# SERVICE BULLETIN

## LANDING GEAR FAIRING MODIFICATION

All McDonnell Douglas Helicopter Systems (MDHS) MD600 helicopters, serial number RN003 thru RN029.

Fairing Installation - Landing Gear, P/N 600N6070 and 600N6075.

**Figure 1. Landing Gear Modification Hardware Installation**

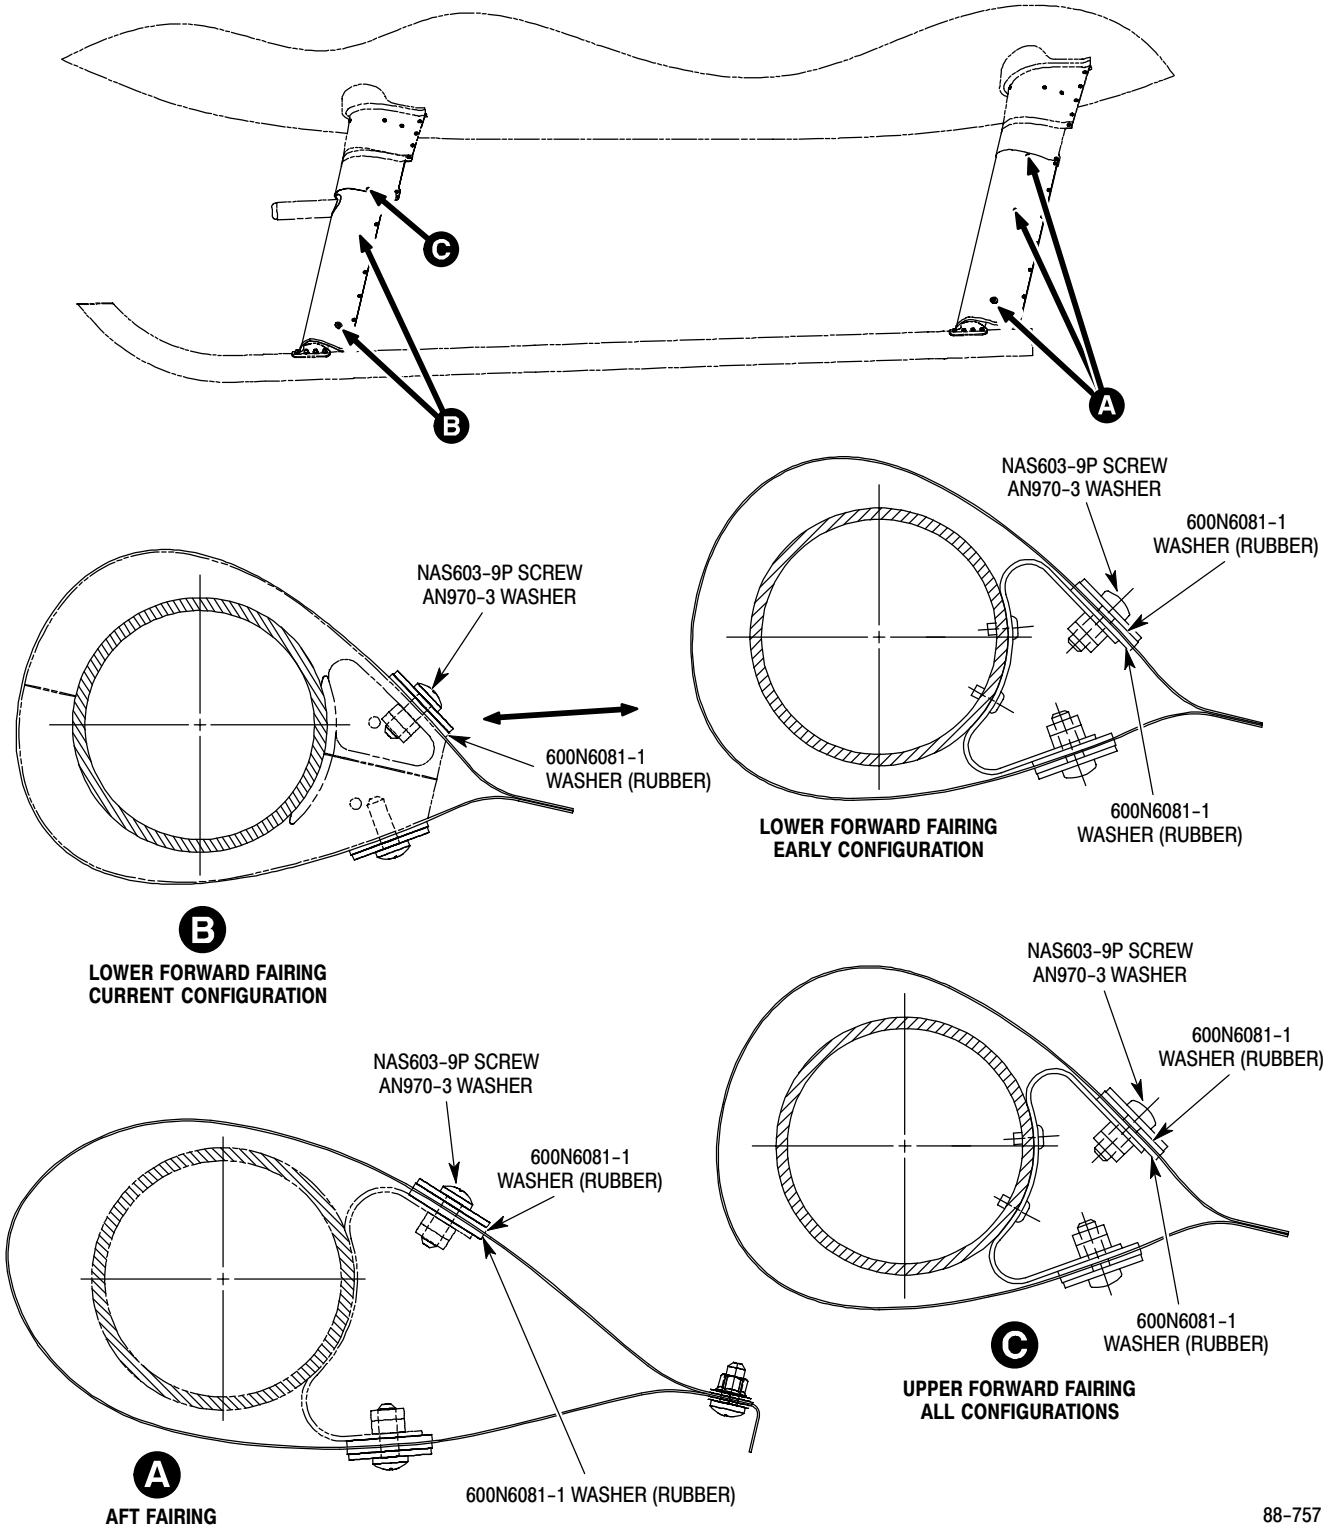
To prevent possible cracking of the landing gear fairing. Failure to comply with the requirement of this Bulletin may lead to the development of cracks in the landing gear fairings.

Procedures in this Bulletin provide owners and operators with information pertaining to installing washers and rubber washers on the landing gear fairings to aid in preventing premature cracking.

- (1). Remove existing screws and washers from forward and aft landing gear struts at locations shown in Figure 1.
- (2). Install replacement hardware as shown in Figure 1.
- (3). Apply touch-up paint as required.
- (4). Record compliance to this Service Bulletin in the Compliance Record section of the helicopter Log Book.
